## PUBLIC HEARING/WORKING SESSION MEMORANDUM

### PETITION #175-21

60, 66-68 Austin Street

Special Permit/Site Plan Approval to allow a for-profit educational use, reconfiguration of the parking stalls, and waivers of associated parking, lighting, and landscaping requirements.

Proposed Site Plan

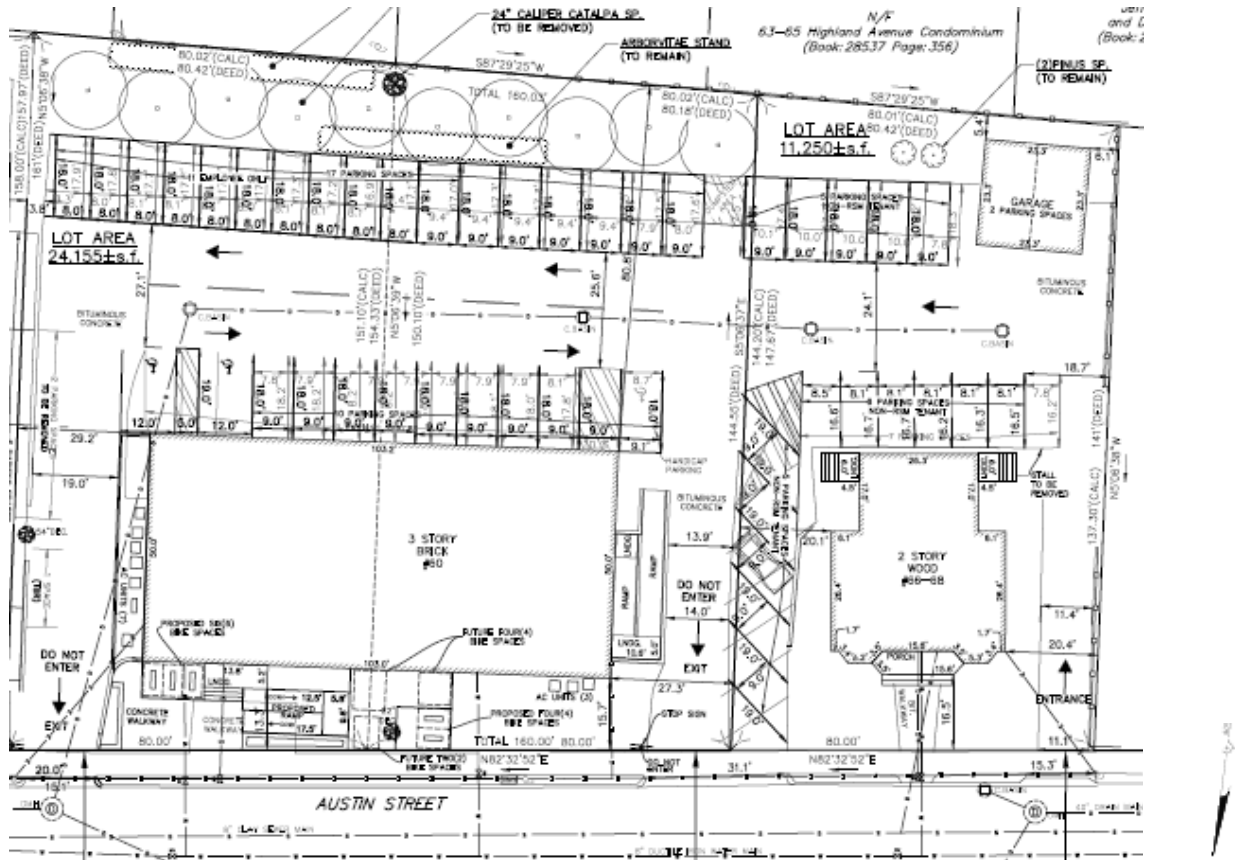
The Petitioner submitted a revised site plan indicating an organized flow of traffic, with vehicles entering the site via the western driveway, which measures 11.1 feet wide, and exiting either the middle driveway or eastern driveway. From previously submitted plans, circulation was expanded to allow vehicles parked directly behind the building to utilize the middle exit driveway, instead of a one-way path of travel to the eastern driveway. Green raised concerns with the drop-off and pick-up loop blocking other businesses on site from exiting. As a result, the middle driveway was changed to exit only and the eastern exit-only drive aisle width was increased 16.5 feet to 19 feet, where 12 feet is required. This allows a "pull over" area where vehicles may pull over while waiting for a student, allowing vehicles to exit the site, and reducing the queue length.

The City and the City's Peer Reviewer recommended that the parking stalls be made more uniform, where existing stalls have varying lengths and widths. The revised plans show uniform spaces of 8-9 feet wide and 18 feet in length for 90-degree parking stalls. In making the middle driveway an exit-only, the angled parking spaces were made to have a depth of 19 feet, meeting the minimum stall depth requirements. The petitioner still requires a waiver for stall dimensions, but the stall dimensions are more compliant with the zoning ordinance.

### Proposed Front Entrance Detail

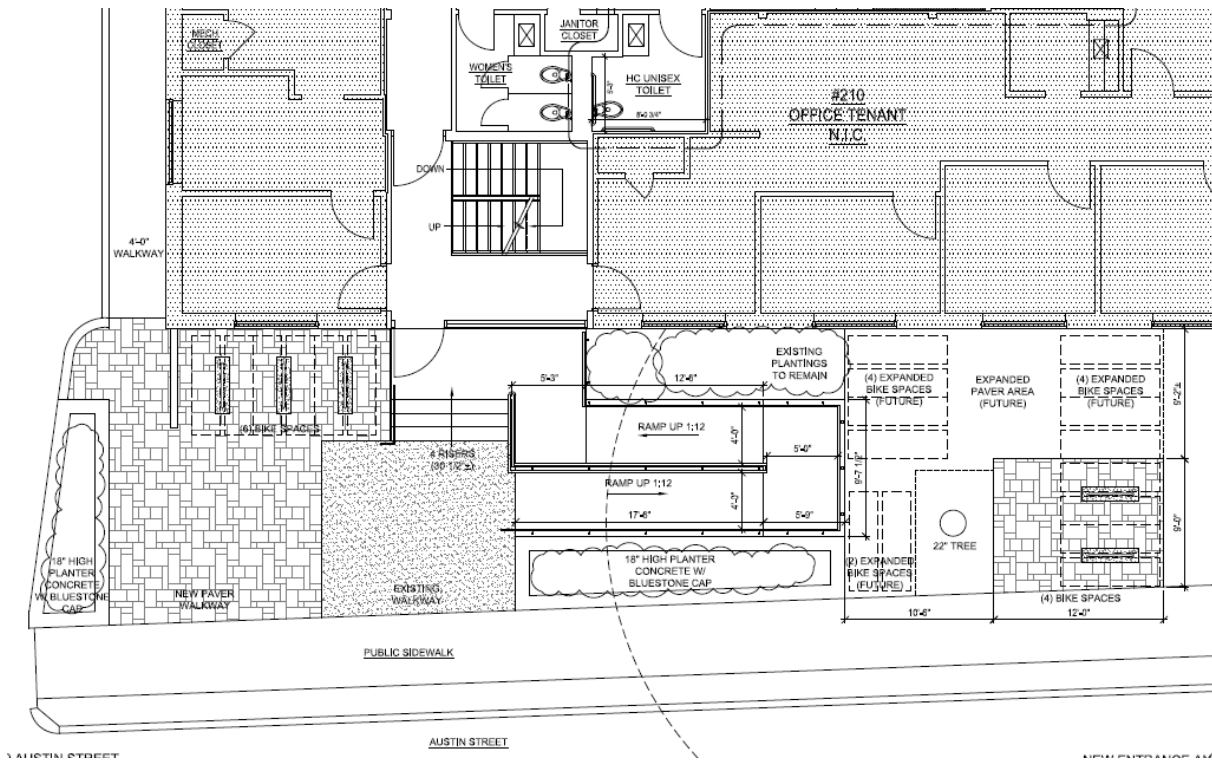
Also included within the revised site plan are enhancements to the front entrance such as an accessible ramp, concrete walkway, and increased bike parking.
